**HUDSON RIVER PCBs REASSESSMENT RI/FS  
RESPONSE TO PEER REVIEW COMMENTS ON THE  
DATA EVALUATION AND INTERPRETATION REPORT (DEIR) AND  
THE LOW RESOLUTION SEDIMENT CORING REPORT (LRC)**

**NOVEMBER 2000**

**U.S. Environmental Protection Agency  
Region II  
and  
U.S. Army Corps of Engineers  
Kansas City District**

**Figure 5-1**  
**Water Column Total PCB Annual Load at Fort Edward, TI Dam, and Schuylerville from GE Data**  
**(Ratio Estimator)**

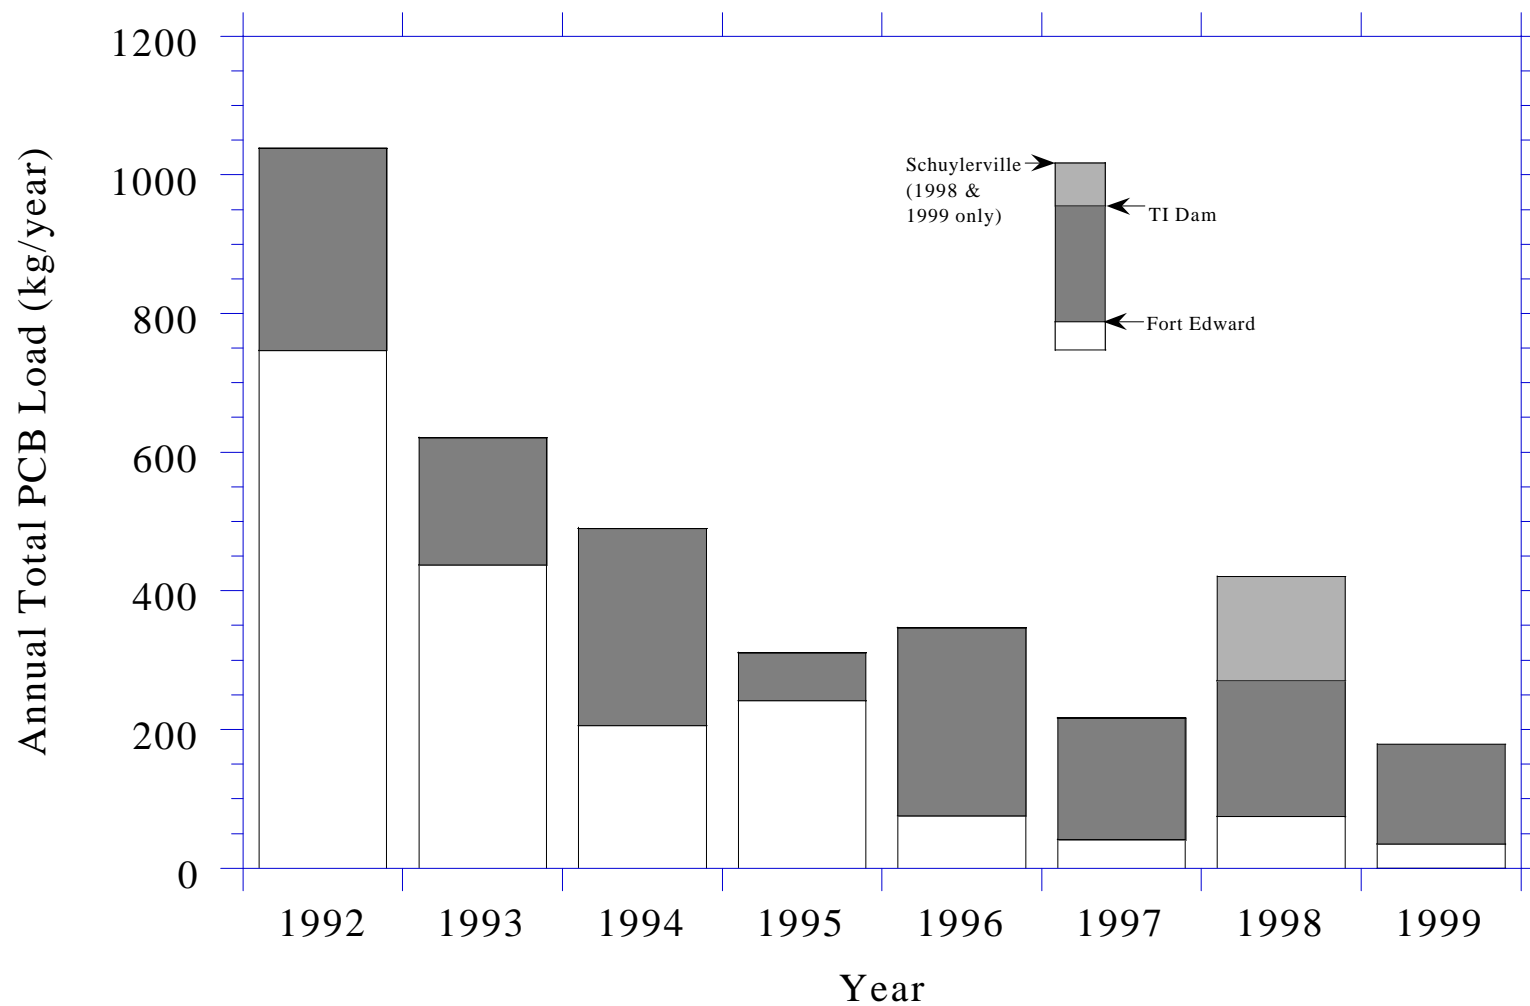
Comment 5: Validate conceptual models and other findings with more recent water column sampling data.

Response 5: Since the completion of the Phase 2 sampling efforts, there have been no similar intensive surveys of the Upper Hudson to directly extend the Phase 2 results. However, as was done in the DEIR, other data sets have been utilized so as to extend and confirm the DEIR findings. To this end GE and USGS data were examined up to 1996 in estimating water column concentrations. The Revised Baseline Modeling Report continued this analysis by including data up to 1997 in its calibrations and utilized more recent data (from 1998 and 1999) as part of model verification. USEPA will continue to review new data as it becomes available, as appropriate. Additionally, the modeling analysis for the Reassessment also serves to examine and validate the conceptual models applied in the DEIR and LRC.

In response to this comment, more recent data obtained by GE on water column concentrations at Rogers Island, Thompson Island Dam and Schuylerville were reviewed. These results were examined for the purposes of examining the incremental load increases between these stations to see if the TI Pool sediments continue to release substantial amounts of PCBs. Water column total PCB annual loads were calculated based on GE weekly water samples and USGS flow data at Rogers Island, TI Dam and Schuylerville using a ratio estimator method (USEPA, 1997). Loads at the TI Dam were corrected to estimate center channel conditions based on the contamination and flow conditions at Rogers Island as mentioned in the Responsiveness Summary for Low Resolution Sediment Coring Report (USEPA, 1999d).

In the conceptual model of the Upper Hudson, TI Pool sediments and, to a lesser degree, sediments between TI Dam and Schuylerville, contribute substantial amounts of PCBs to the water column during the warmer months of the year. Thus, if this is true, then water column load should increase substantially relative to Rogers Island each year. This has already been examined to a degree by GE and its consultants (QEA, 1998). The evaluation below, serves to update the QEA analysis. Figure 5-1 compares the water column load for the three stations. Clearly evident in the most current data available is the substantial load gain between Rogers Island and TI Dam. A smaller load gain
